BINGHAMTON
UNIVERSITY
STATE UNIVERSITY OF NEW YORK

MEMORANDUM

SUBJECT: Addendum # 4
Project #: C071086
Title: East Gym Addition – All Trades

3. A4.100 – Ground Floor Ceiling Plan

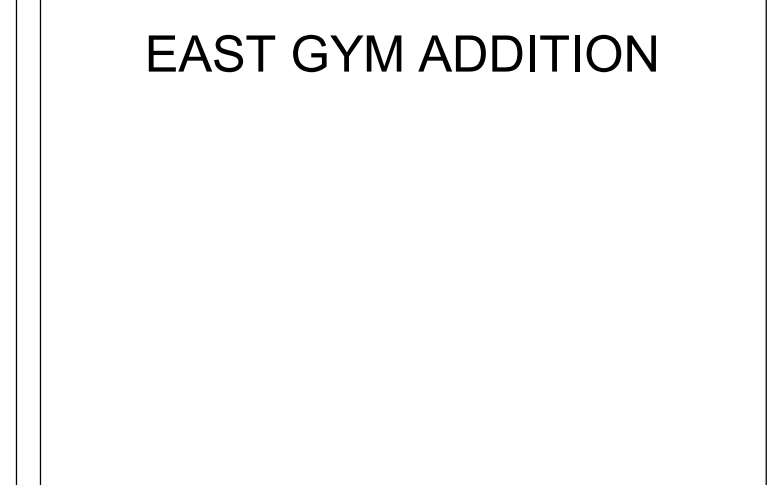
- a. Remove gypsum ceiling in Vestibule G00A.
- b. Remove ACT ceiling in Vestibule G00D.

A9.101

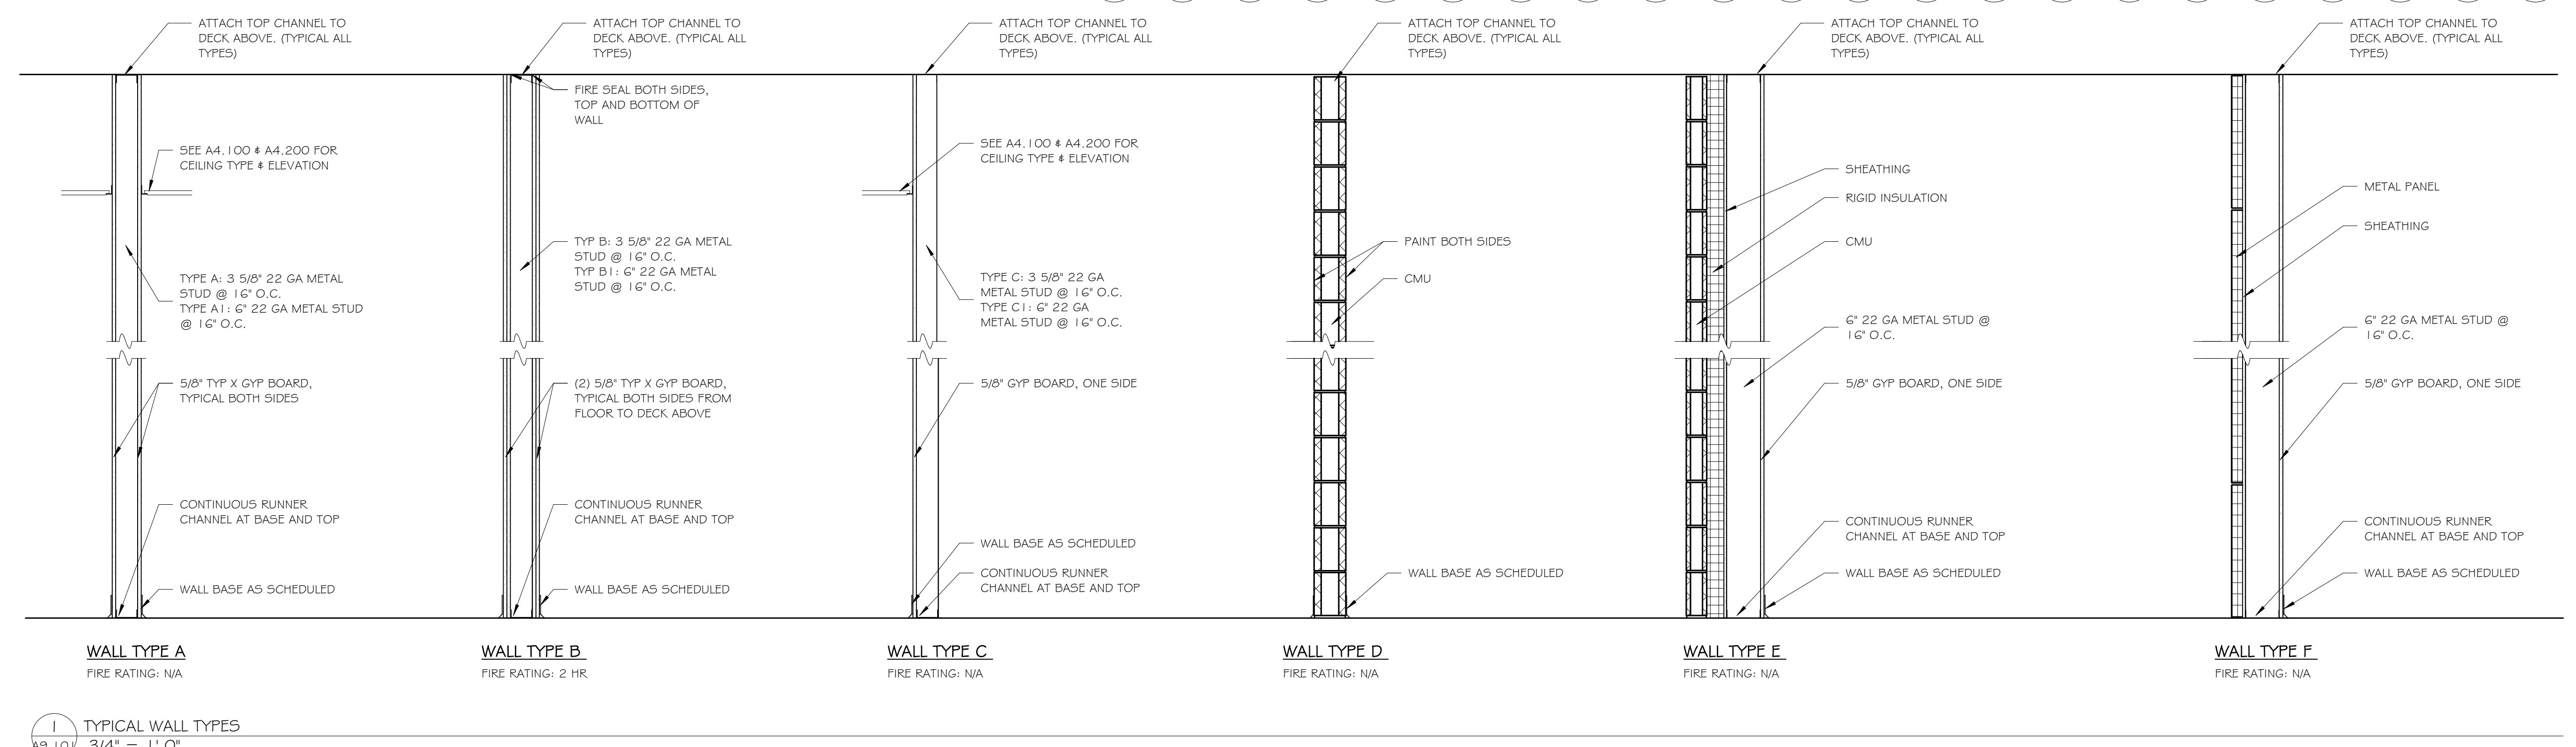
- a. Add PT-3 to finish types
- b. Room Finish Schedule:
 - i. Changed ceiling type and finish for Vestibule G00A & G00D
 - ii. Changed finish for all areas with exposed ceiling
 - iii. Changed concrete type from conc-2 to conc-1 in Mech room G07, Electric Room G09A, Mech Room G09B, Equipment Room G09C, and Equipment G20

TYPICAL TYPE J HEAD AND JAMB DETAIL

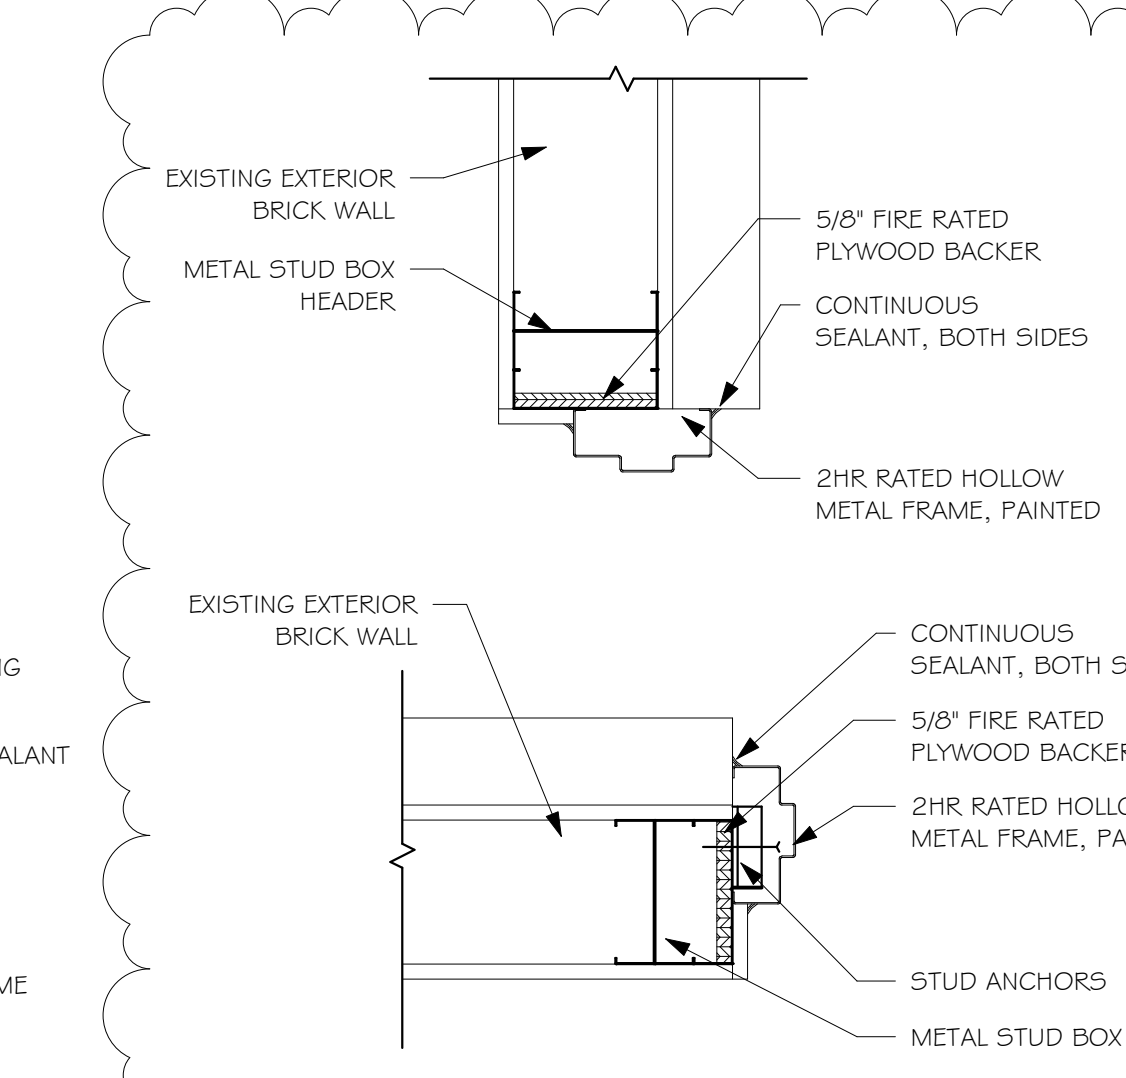
- a. 1/A9.200 – addition of Type J head and jamb detail
- b. Door Schedule – addition of door G00B.1
